EUROTEX KNITWEAR LTD. (Extension)

Nayamati, Kutubpur, Fatullah, Narayanganj-1400
(23.649037, 90.501637)
13 August 2023

Building Information

Design review of cantilever beam

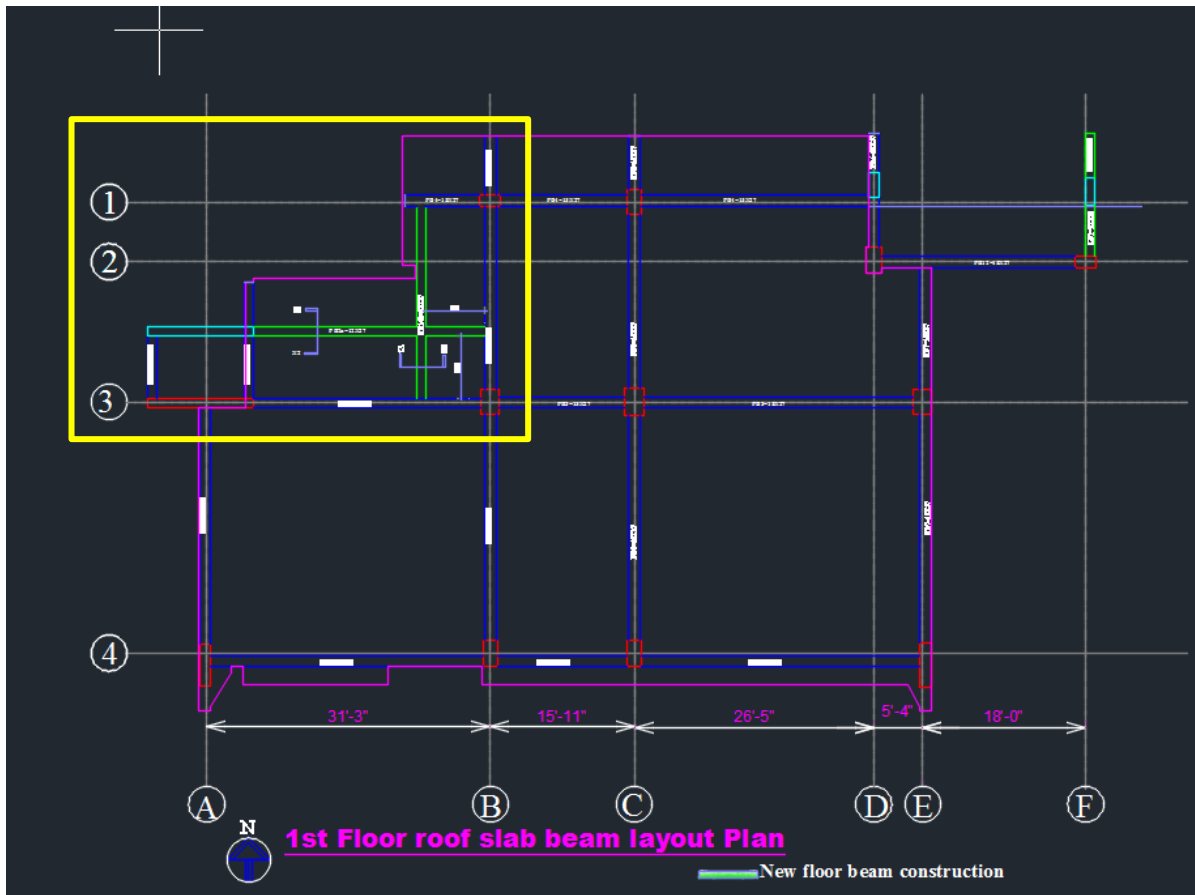
The marked beam cut to separate the buildings and the beams became cantilever beam. The building engineer is required to check the reinforcement of the beam & review the design.

Inconsistency in as-built drawing

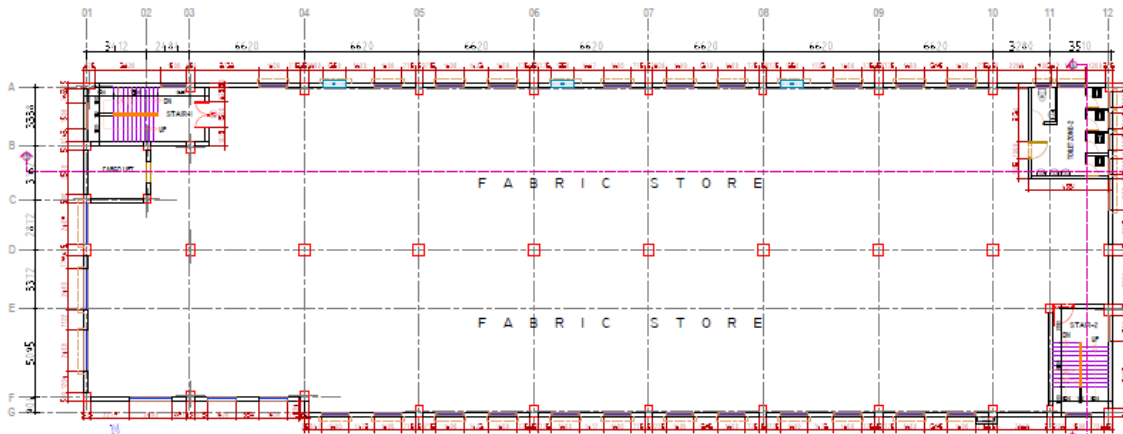
During inspection, difference found between architectural layout drawing and onsite floor use. Also, 250 mm build-up at toilet area was not shown in as-built drawing. Building engineer is required to survey the full building and update the as-built drawing accurately.
